Addendum No. 1

Project: North Carolina State University
Textiles Complex
Flex Factory Renovations
Raleigh, NC 27607

ADDENDUM 01

Project: NCSU – Textiles Complex – Flex Factory Renovations
SCO ID#: 23-26253-01A
NCSU Project ID: 202220031
Date: June 16, 2025

M210

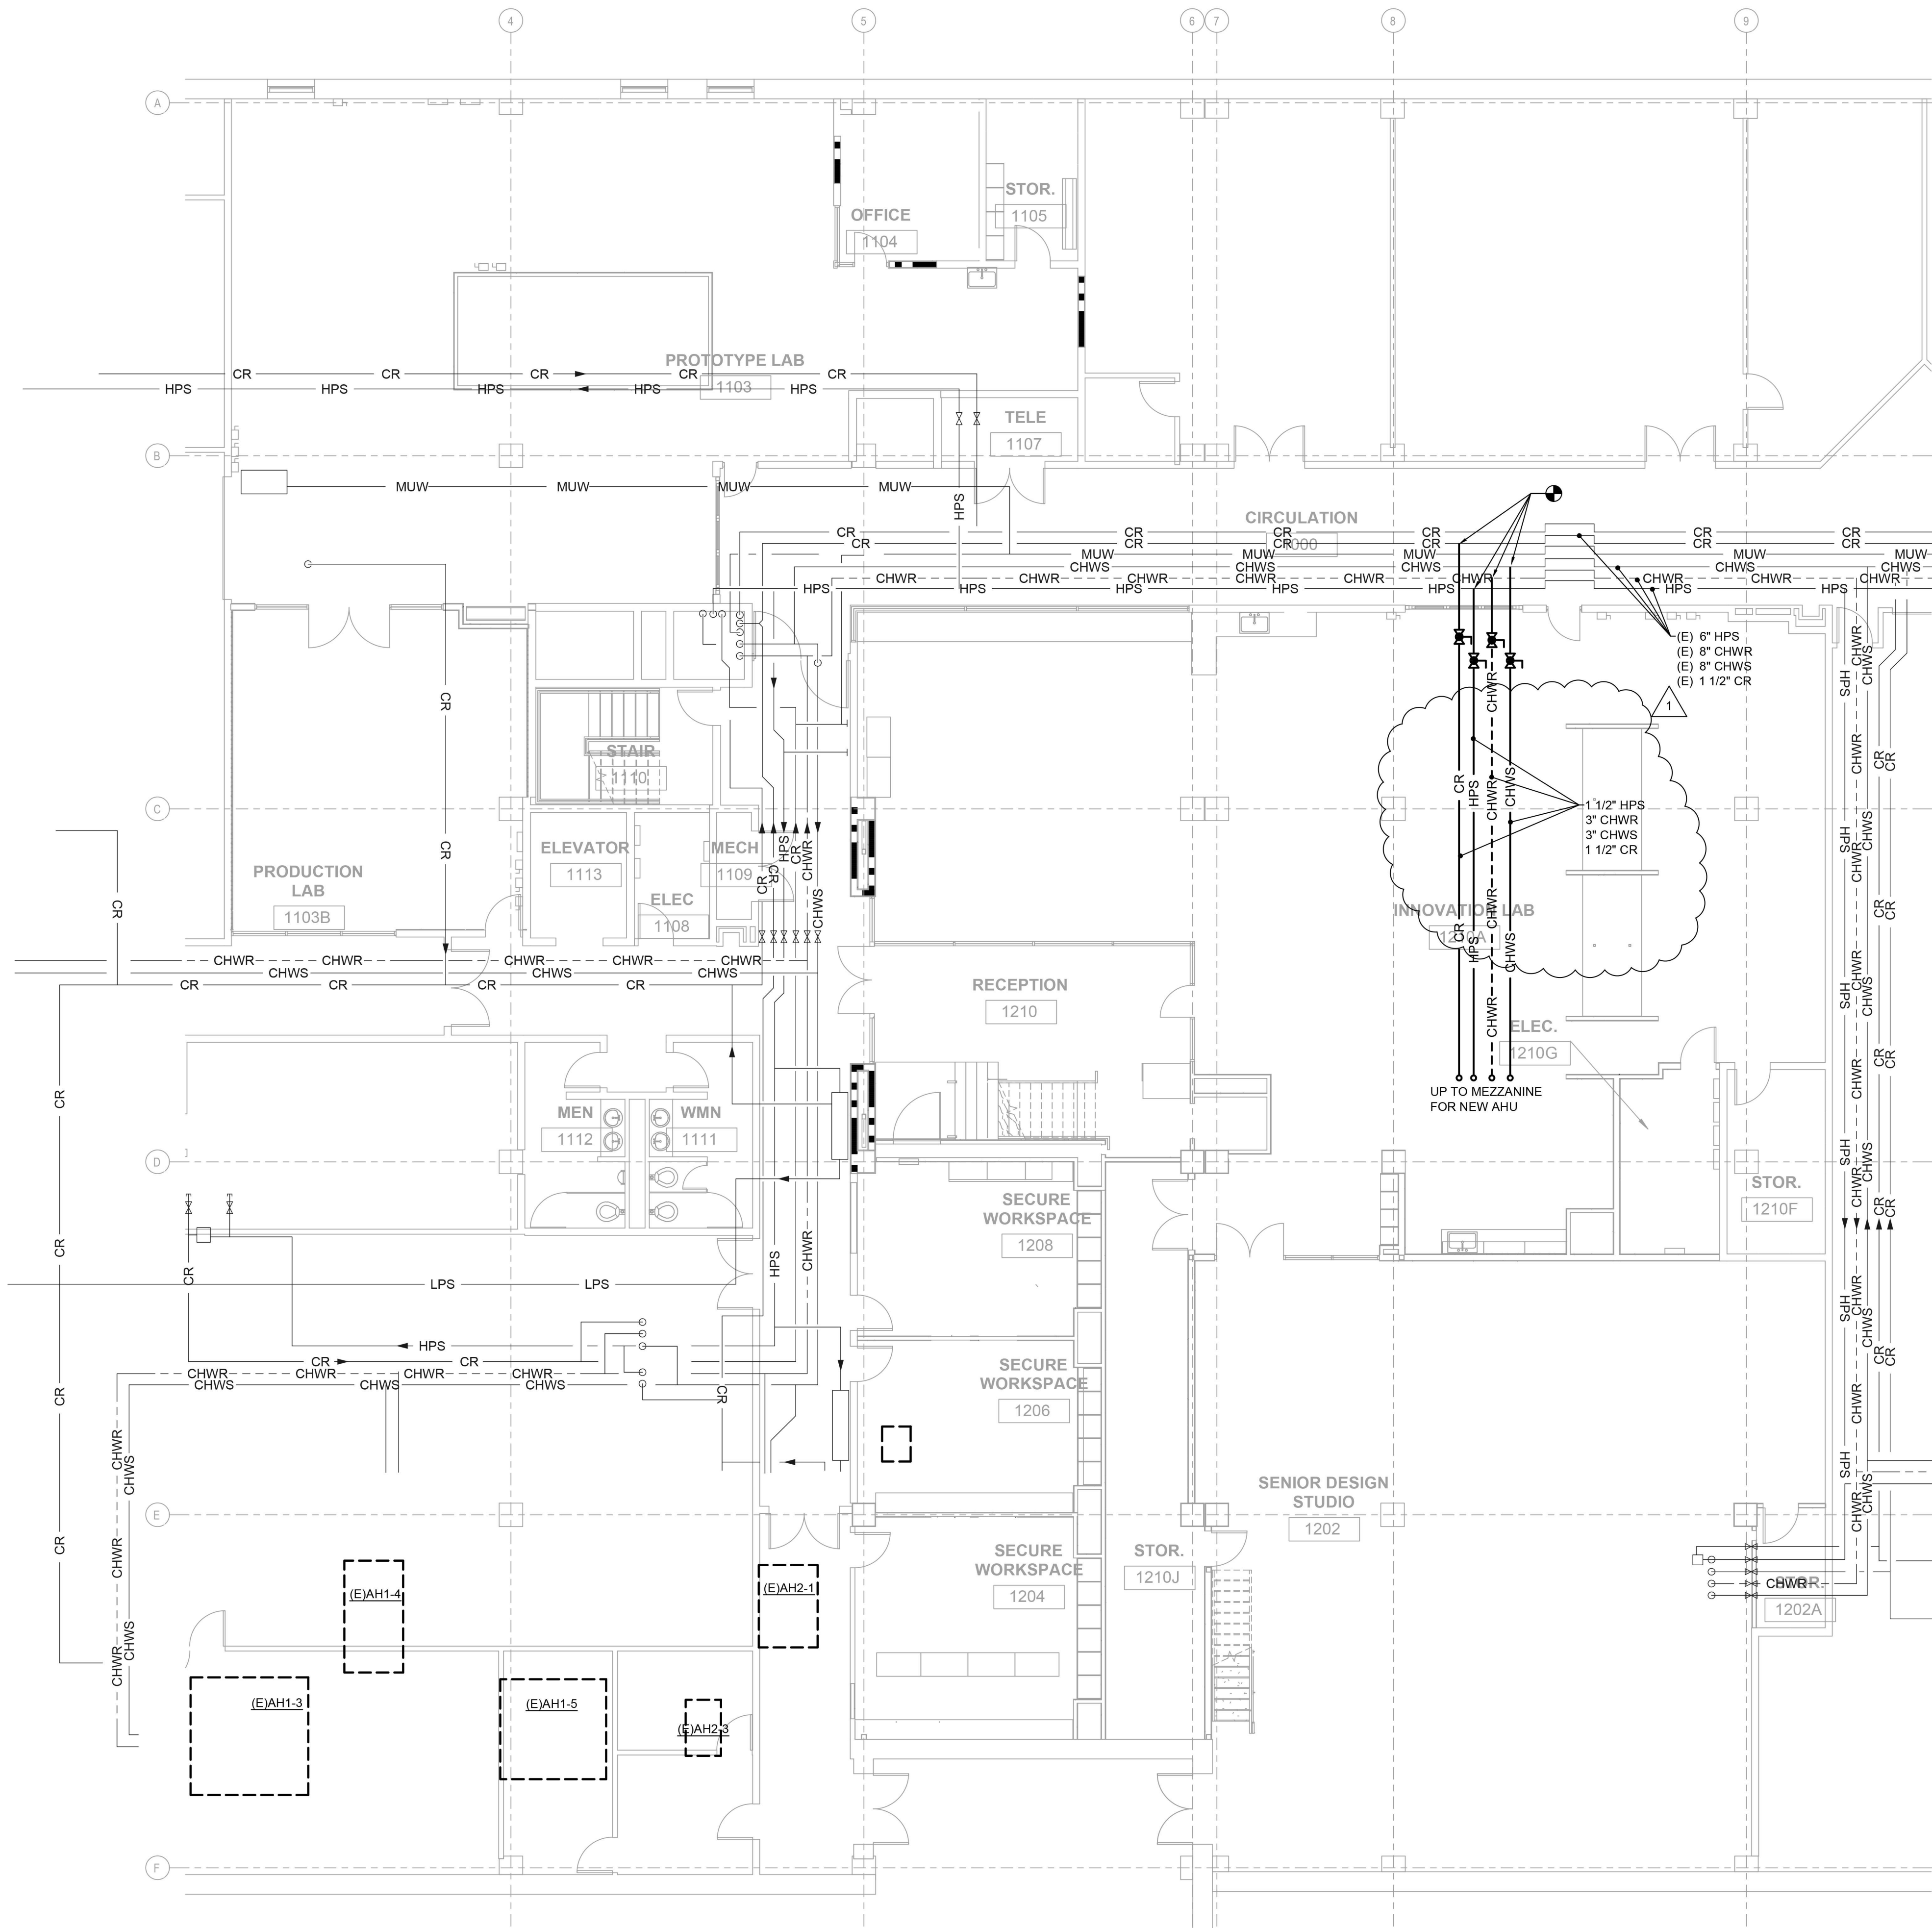
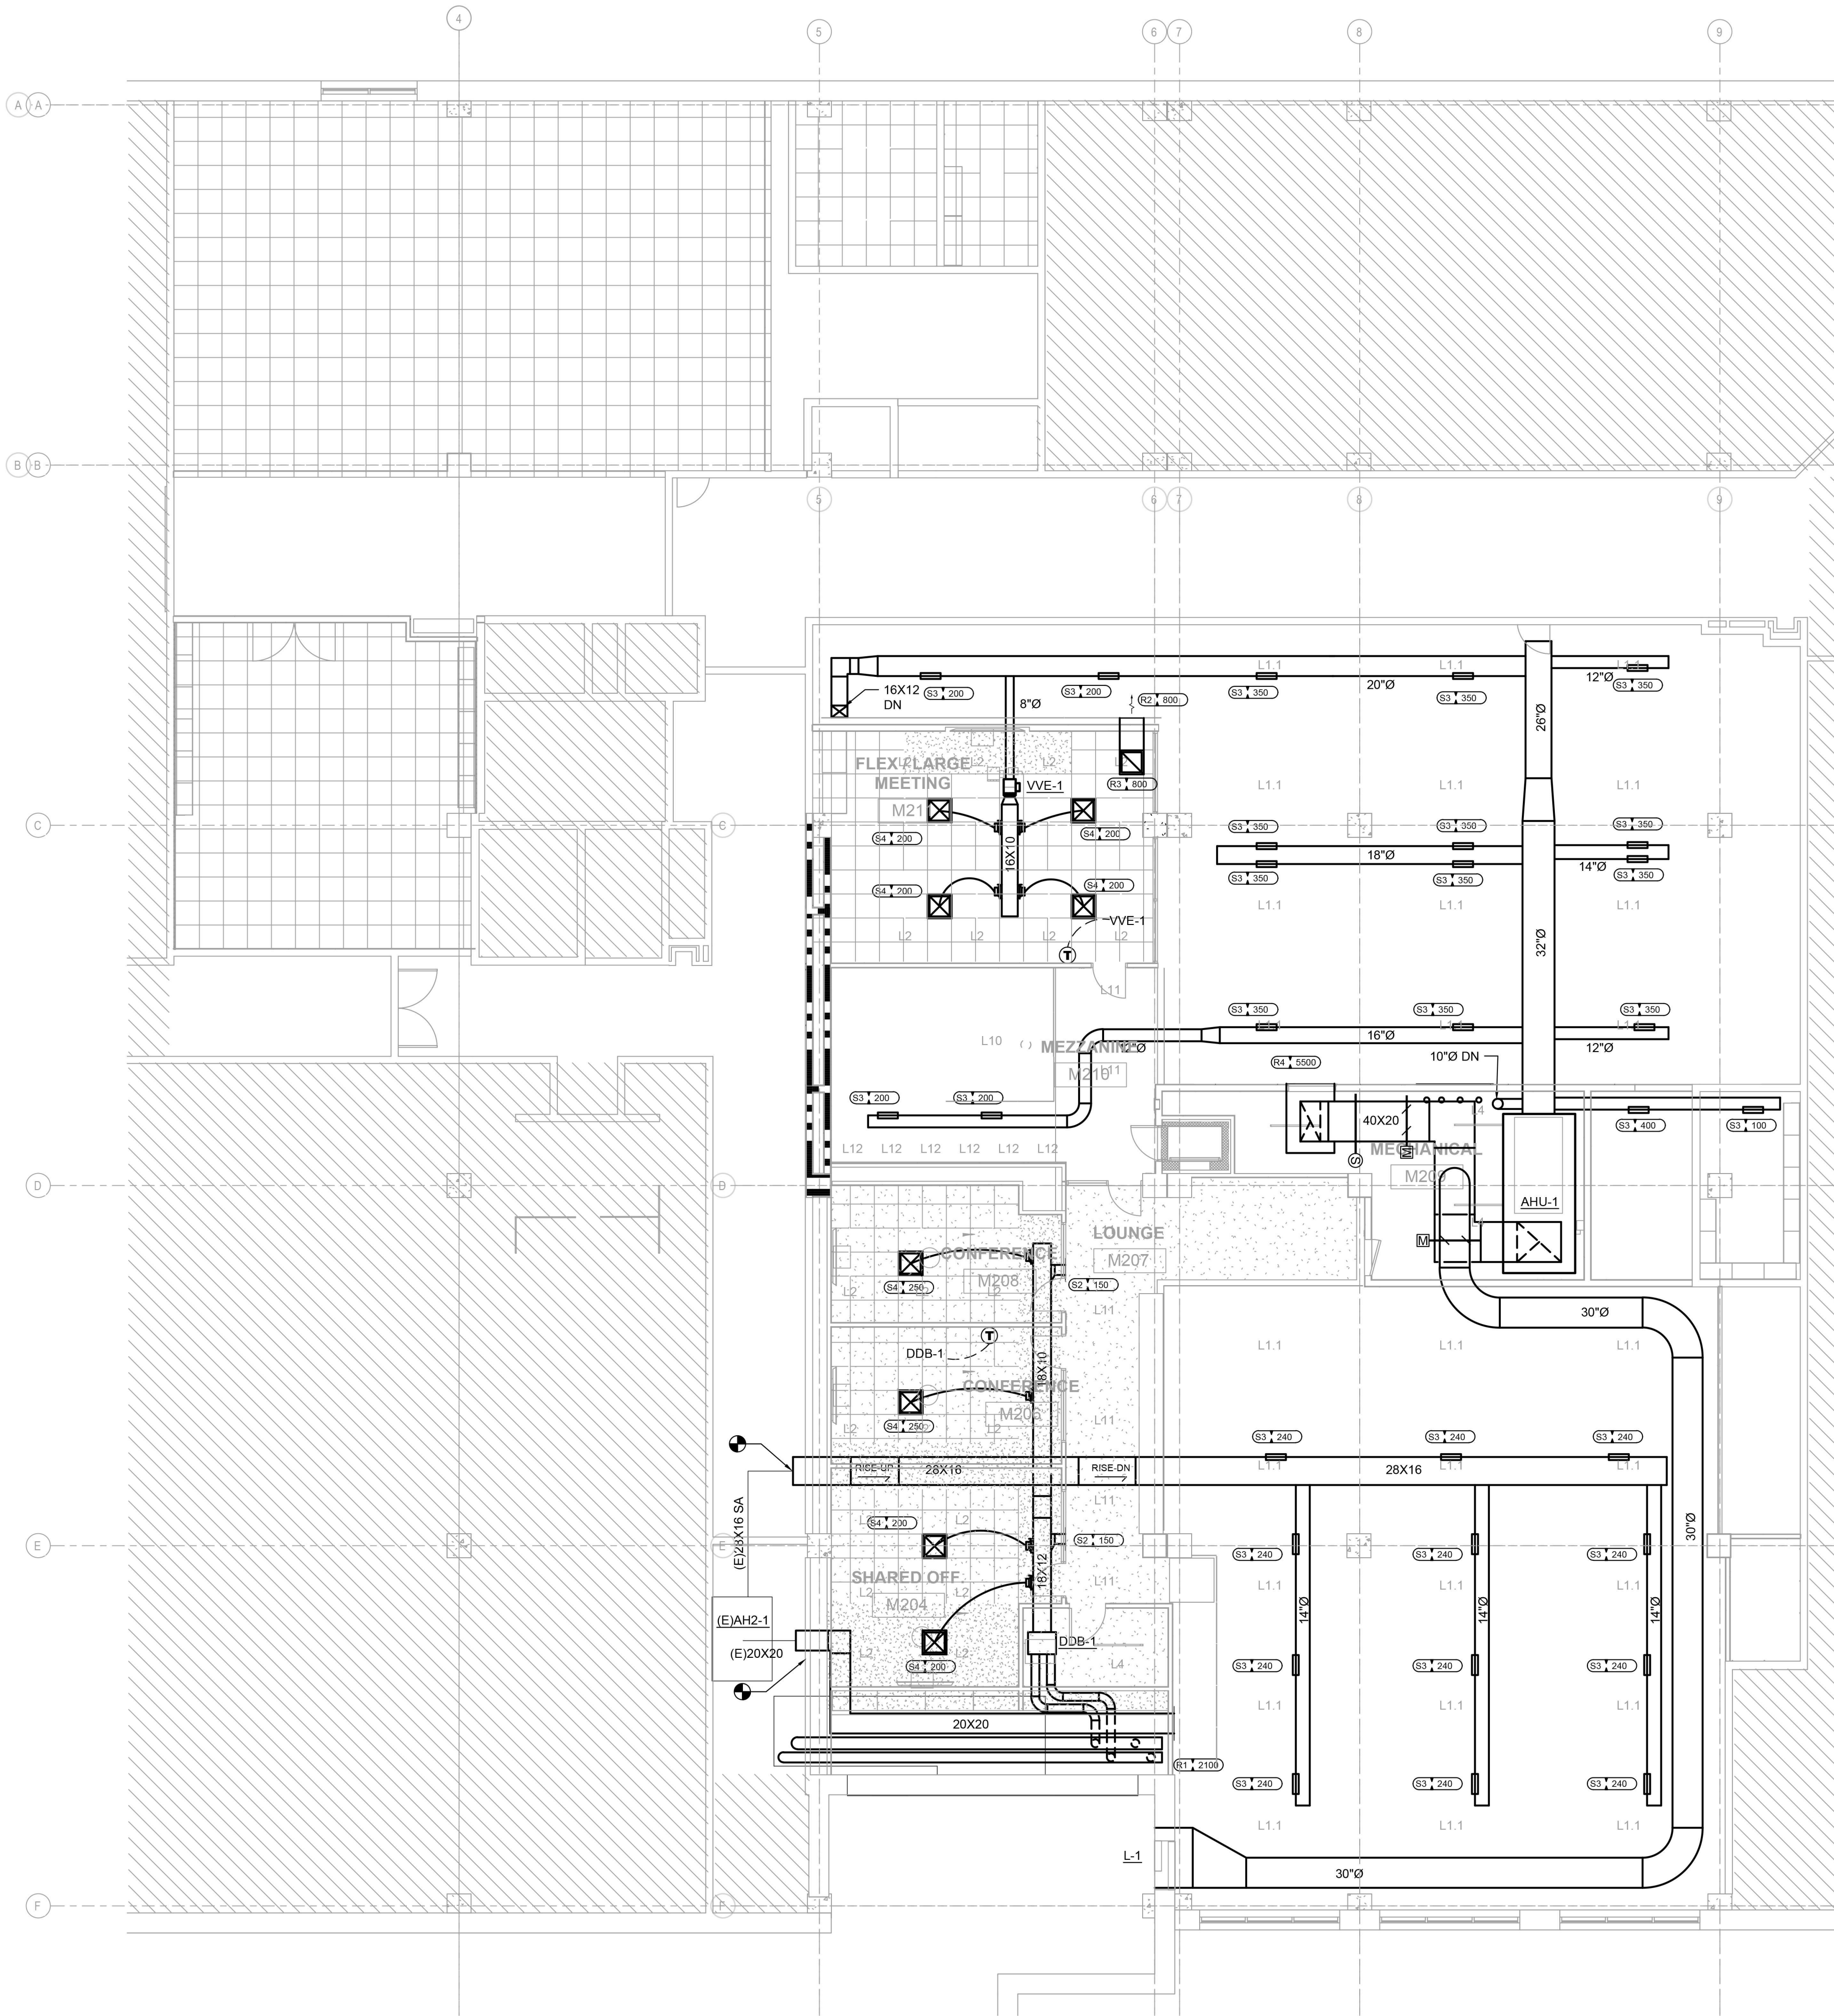
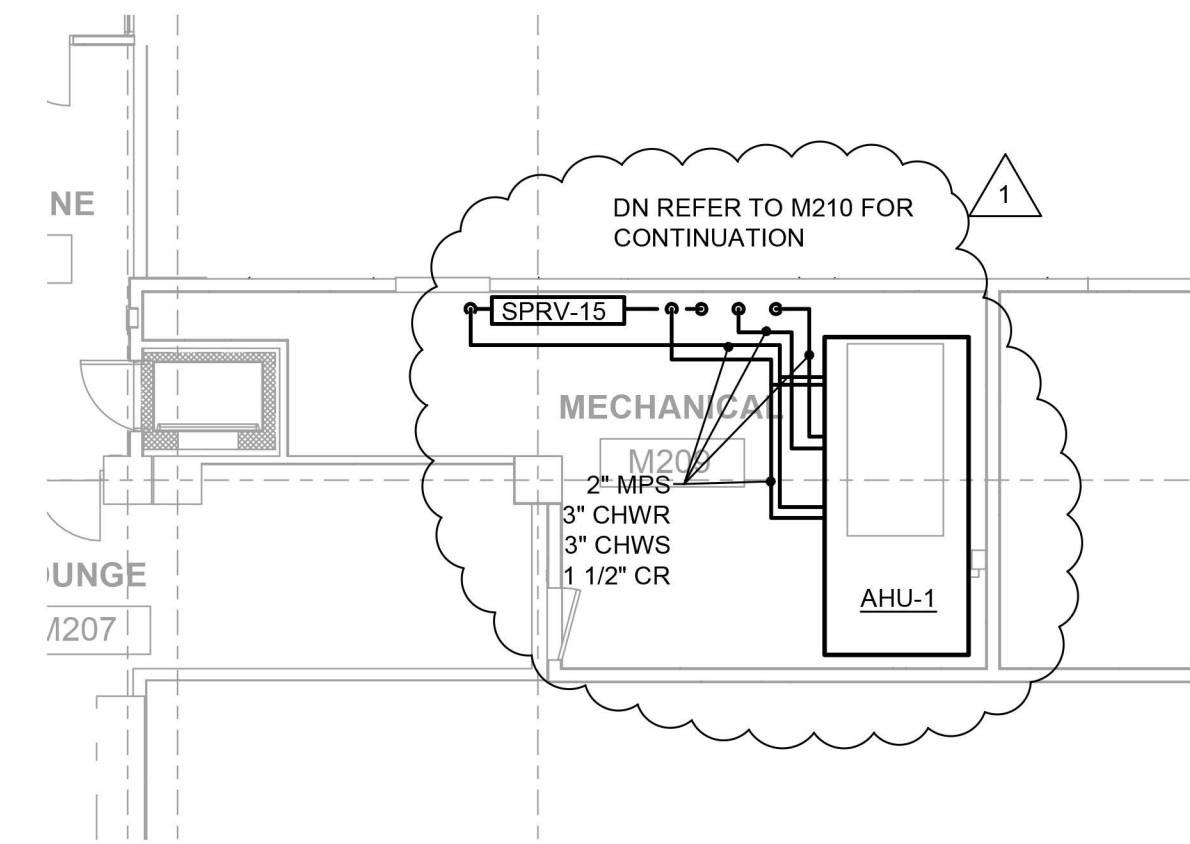
- RFI No. 007 The steam piping going to AHU-1 is labeled as HPS (high pressure steam), is this correct and if so, what is the steam pressure, the heating coil on the AHU-1 schedule is only rated for 10psi?*

Response: Provide steam pressure reducing station as indicated in the revised sheets M002, M210, M300.
- RFI No. 008 Is there another time that a walk-thru would be possible?*
